Access Compliance Report Public Rights-of-Way (Curb Ramps)

Main Street: TUBEROSE_ST Cross Street: S_SELLAS_RD Location: SW

ADA ID: RPRK211103140229 Ramp Type: Type 4 - Parallel Initial Pass/Fail: Fail Overall Compliance: No Severity Score: 2

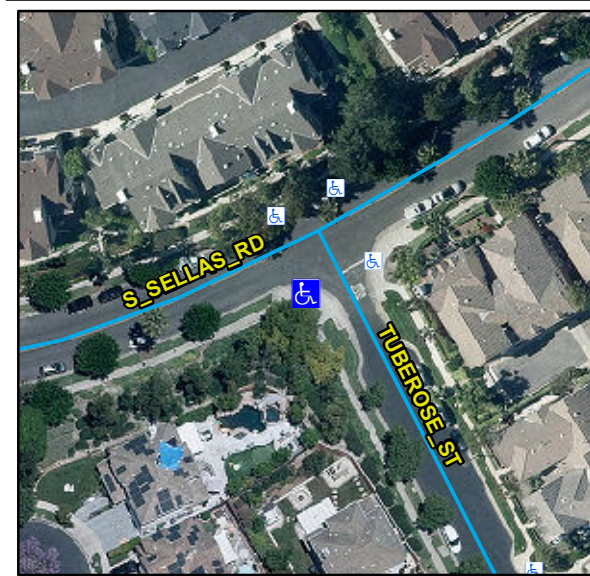
Compliance	Description	Data	Compliance	Description	Data
N/A	Ramp Length LT (in)	127	N/A	Ramp Length RT (in)	131
Yes	Ramp Width LT (in)	91	Yes	Ramp Width RT (in)	91
Yes	Ramp Run Slope LT (%)	7.7	Yes	Ramp Run Slope RT (%)	1.4
No	Ramp Cross Slope LT (%)	3.5	No	Ramp Cross Slope RT (%)	2.5
N/A	Landing Present	N/A	N/A	DWS Provided	N/A
N/A	Landing Length (in)	N/A	N/A	DWS Contrast	N/A
N/A	Landing Width (in)	N/A	N/A	DWS Length (in)	N/A
N/A	Landing Run Slope (%)	N/A	N/A	DWS Full Width	N/A
N/A	Landing Cross Slope (%)	N/A		DWS Offset Type	N/A
N/A	Landing Movement Obstructed?	N/A	N/A	DWS Offset Left (in)	N/A
	Landing Movement Type	N/A	N/A	DWS Offset Right (in)	N/A
N/A	Landing Shared	N/A			
N/A	Clear Space	Yes			
N/A	Clear Space To Crosswalk (in)	N/A			
N/A	Marked Crosswalk 1	No	N/A	Marked Crosswalk 2	No
	Crossing 1 Direction	E		Crossing 2 Direction	N
	Marked Crosswalk 1 Width (in)	N/A		Marked Crosswalk 2 Width (in)	N/A

Remove & Replace Curb Ramp With Two New Directional Ramps or Equivalent.
